Feasibility Study Report for Parcel F

**Hunters Point Shipyard
San Francisco, California**

April 30, 2008

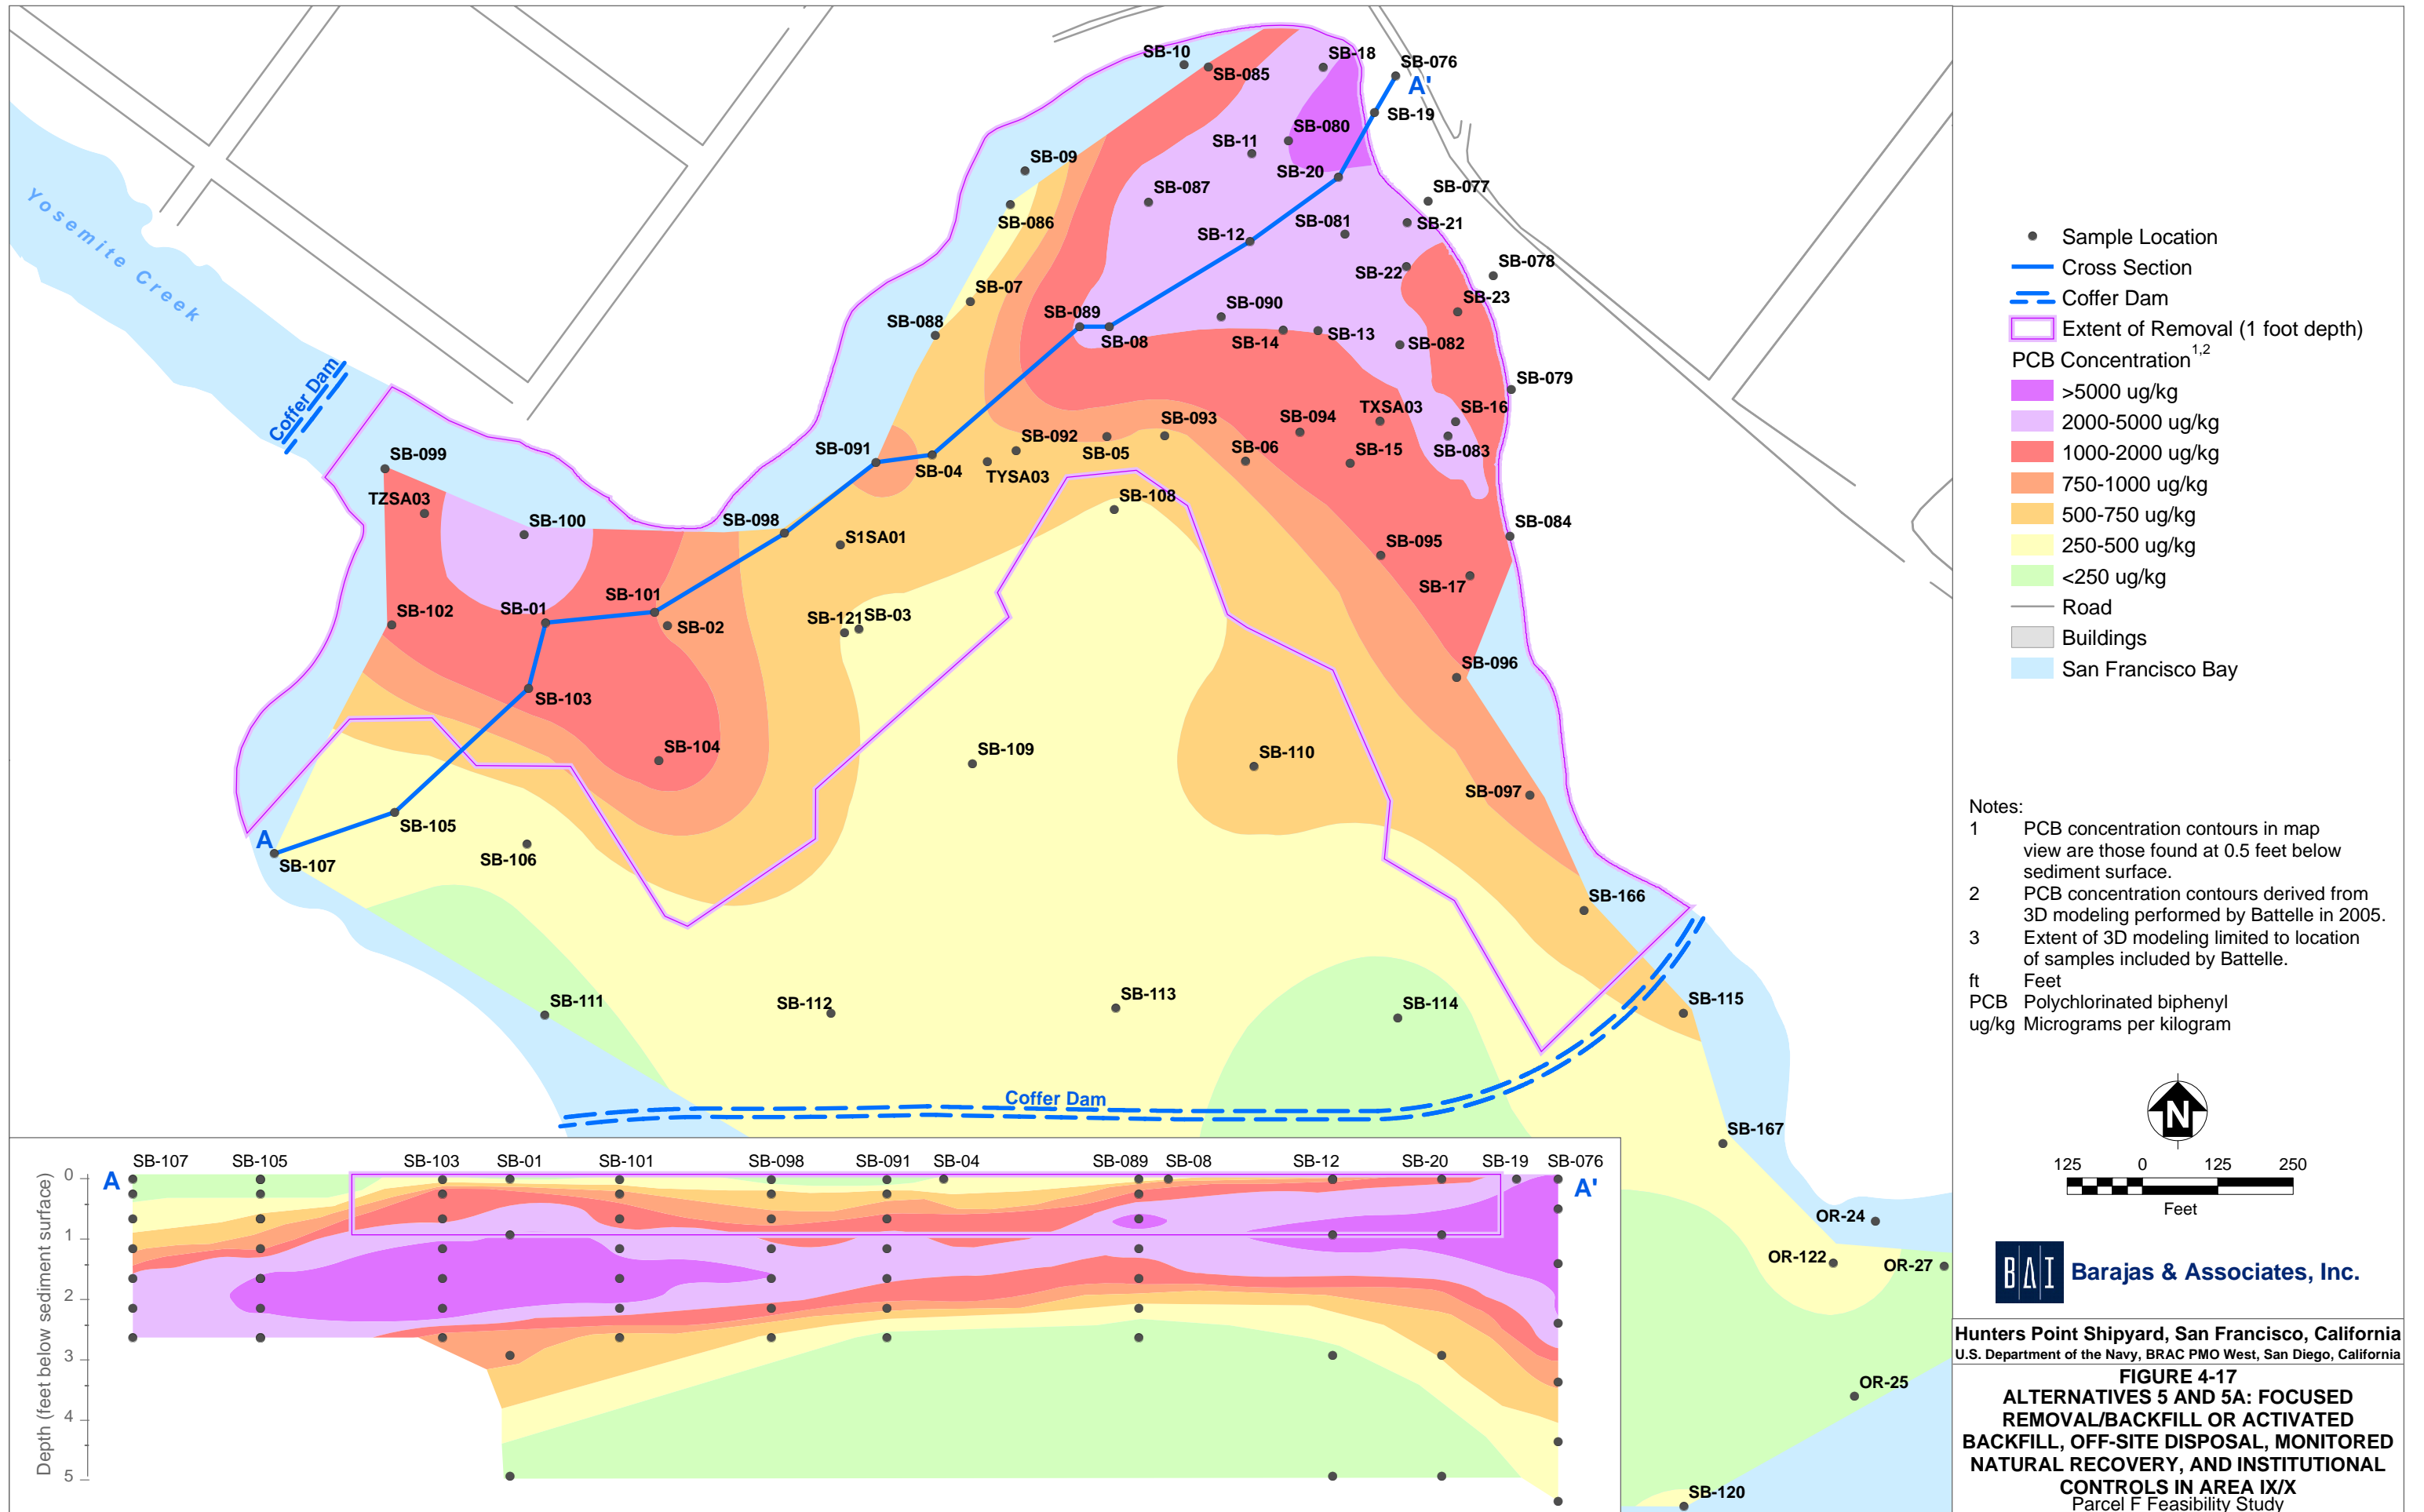
- 1. Comment:** Figure 4-9 is missing values for removal depths.

Response: The figure has been revised.
- 2. Comment:** Revise Figs. 4-12, 4-17, and 4-20 to include data points in the cross-section as was done for Fig. 4-9.
